AMENDMENT OF SOLICITATION / MODIFICATION OF CONTRACT			1. Contract Number		Page of Pages		
					1 9		
2. Amendment/Modification Number Amend No.2		3. Effective Date See item 16C		4. Requisition/Purchase		5. Solicitation Caption : Petworth Library Exterior Restoration

Section L, Instructions, Conditions and Notices to Bidders,
Paragraph 11, Questions About the Solicitation:

Questions and Answers:

1 NEW SIGN

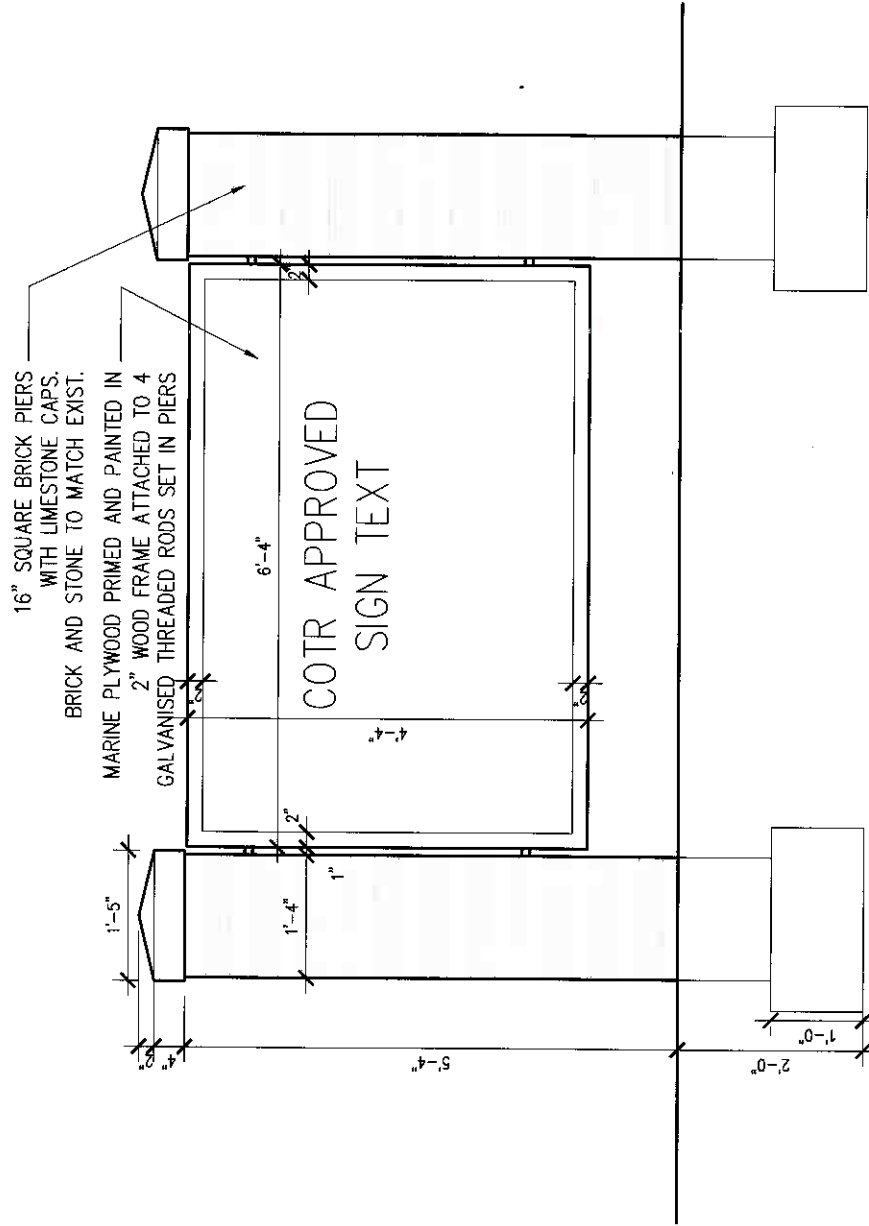
- 1. Question:** Sheet L1.1 states signage to be confirmed with COTR. Please provide detail for signage or an allowance.

Answer: See Attachment J.12.
- 7. Question:** Reference dwg. L1.1, New Signs (2ea). Please provide specifications & details.

- 16. Question:** Drawing L1.1 is called for New Sign, Confirm detail with C.O.T.R, please provide the detail specification, drawings and list of manufacturer.

Answer: See Attachment J.10.
- 2. Question:** Drawings indicate 2 new flagpoles, please provide details for flagpole (size)?

ASK 1 1/2" = 1'-0"

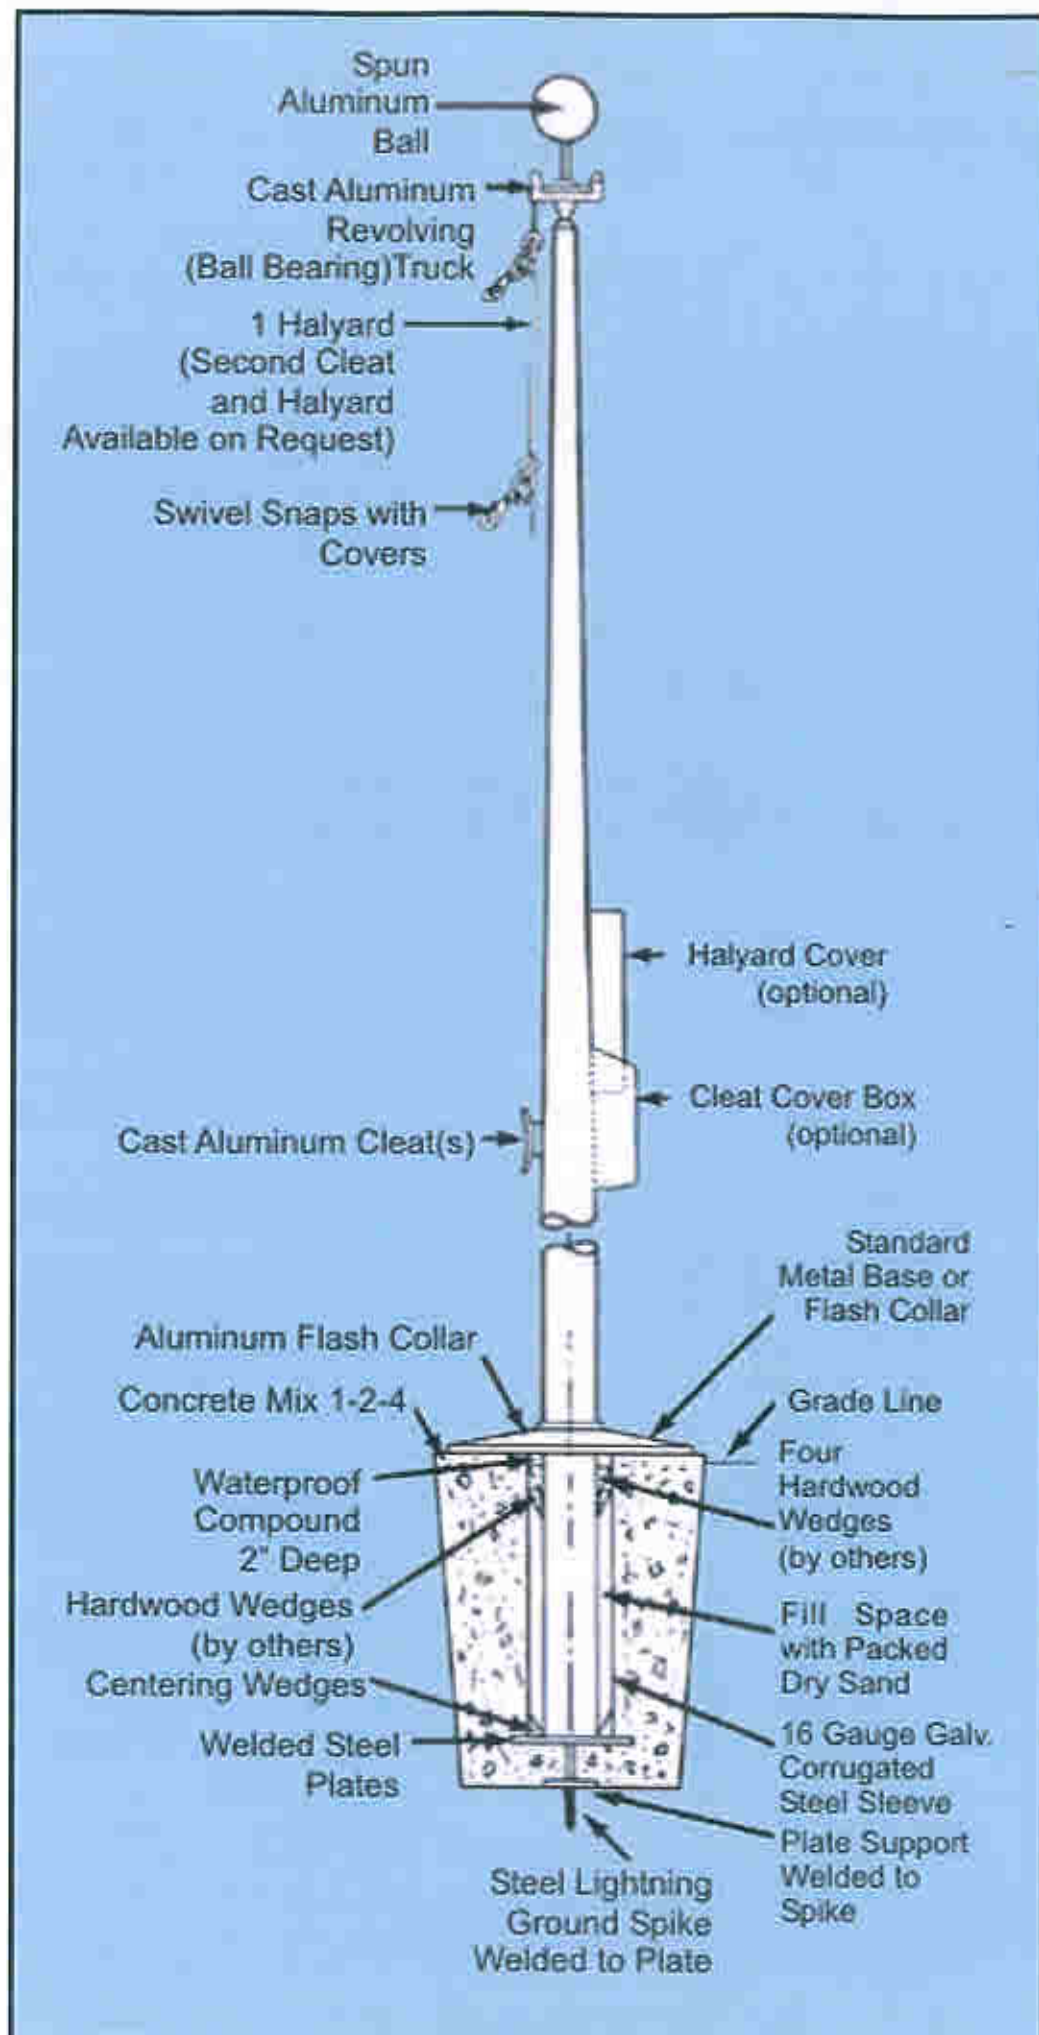
- Answer:** See Answer #1.
- 17. Question:** Drawing L1.1 is called for New Flagpole, See Detail 10, Sheet L4.3. Please provide the height of the new flagpole, detail specification and list of manufacturer.

Answer: See Attachment J.11.
- 3. Question:** Plumbing drawings for installation of Drinking Fountain is indicated as an additional item under Dwg. A1.4, Spec. Section 02870, Site Furnishings. Narh Mech. Has informed me that they have already provided plumbing on site for this feature. Is this correct? If so, will GC be installing drinking fountain? Please provide manufacturer for drinking fountain to be installed?

PILLAR DETAIL
1/4" = 1'-0"

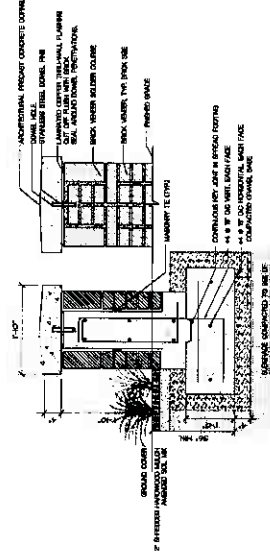
44. Question: Detail 6/L4.1, Pillar Detailed does not adequately dimension the structural concrete footing size;

Answer: See Attachment details in Attachment J.12.

READING ROOM SEAT WALL DETAIL
1/4" = 1'-0"

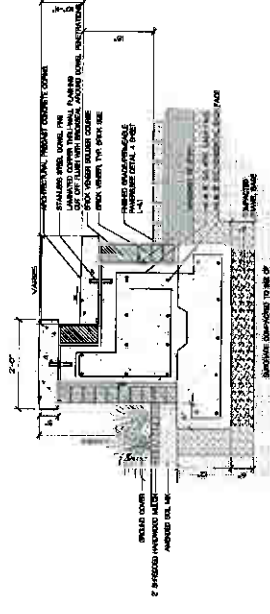
45. Question: Detail 7/L4.1 Reading Room Seat Wall Detail does not adequately dimension the structural concrete footing size; or the architectural Precast concrete coping size;

Answer: See Attachment Detail 7 in Attachment J.12.

Mecho®/5 Wide Bracket with optional fascia

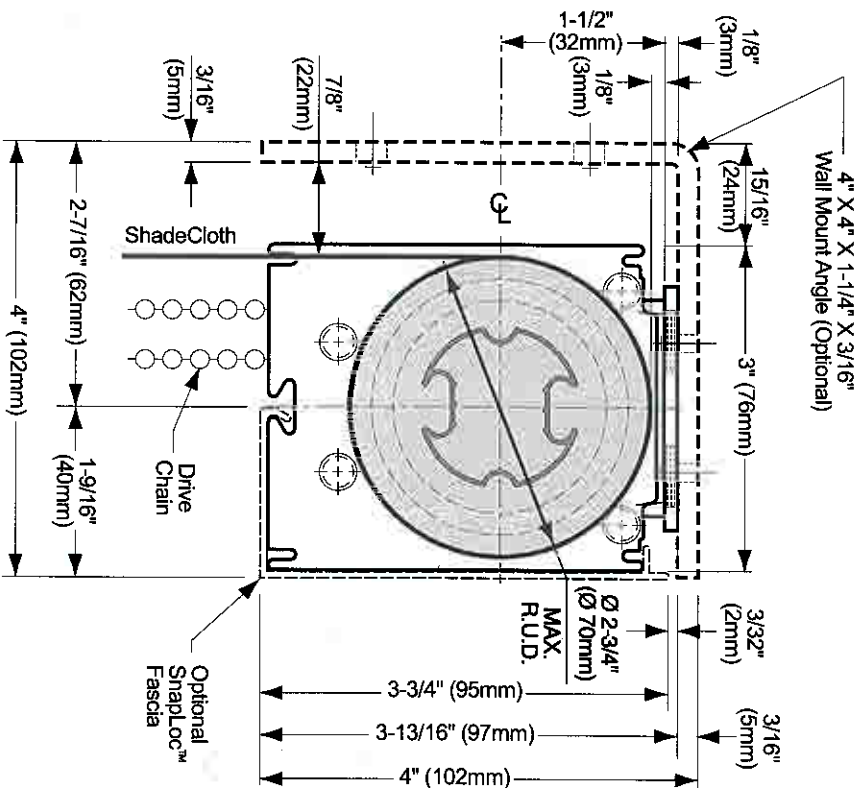
- Answer:** See Drawings L1.1-3 and L4.3.
- 15. Question:** On drawing A5.1 in General Notes H states remove all existing pull down shades and replace with MECHO-SHADES. We need detailed Specs. on what MECHO-SHADES to use for this project and any alterative manufactures. Please advise.

- Answer:** Use Mecho/ 5 Standard with fascia. (See Attachment J.14).

1. READING ROOM SKYLIGHT DETAIL
1/4" = 1'

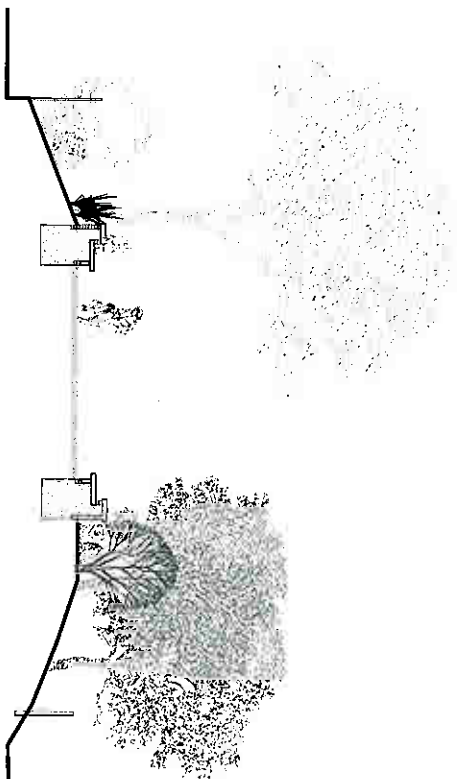
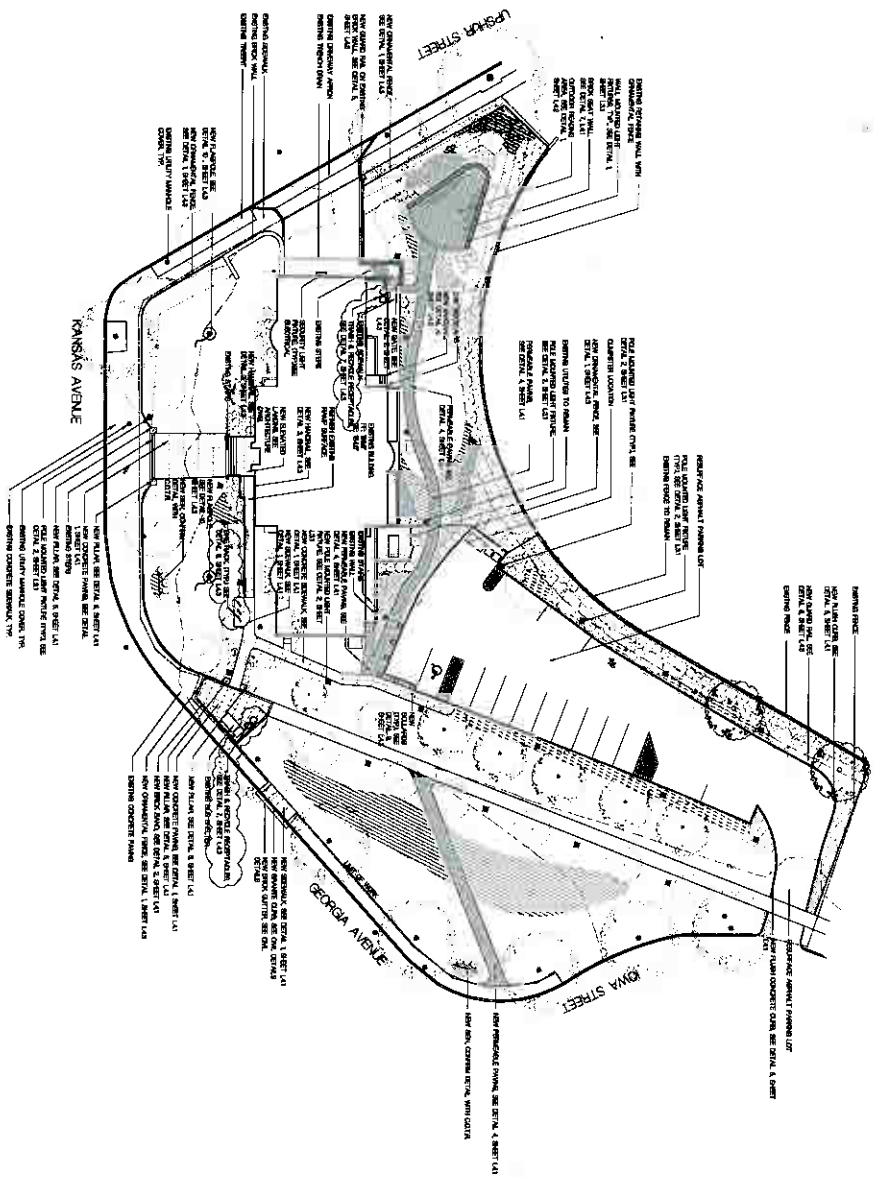
- Answer:** Fence in front of door 001 is to be removed.
- 43. Question:** Detail 1/L1.1, Site Plan does not adequately dimension the length/geometry of the outdoor reading room brick seat wall; cross-referencing against Detail 1/L4.2, Reading Room Seat Wall Detail does not alleviate this problem

- Answer:** See revised 1/4"=1'-0" scale det. 1/L4.2. See Attachment J.17.
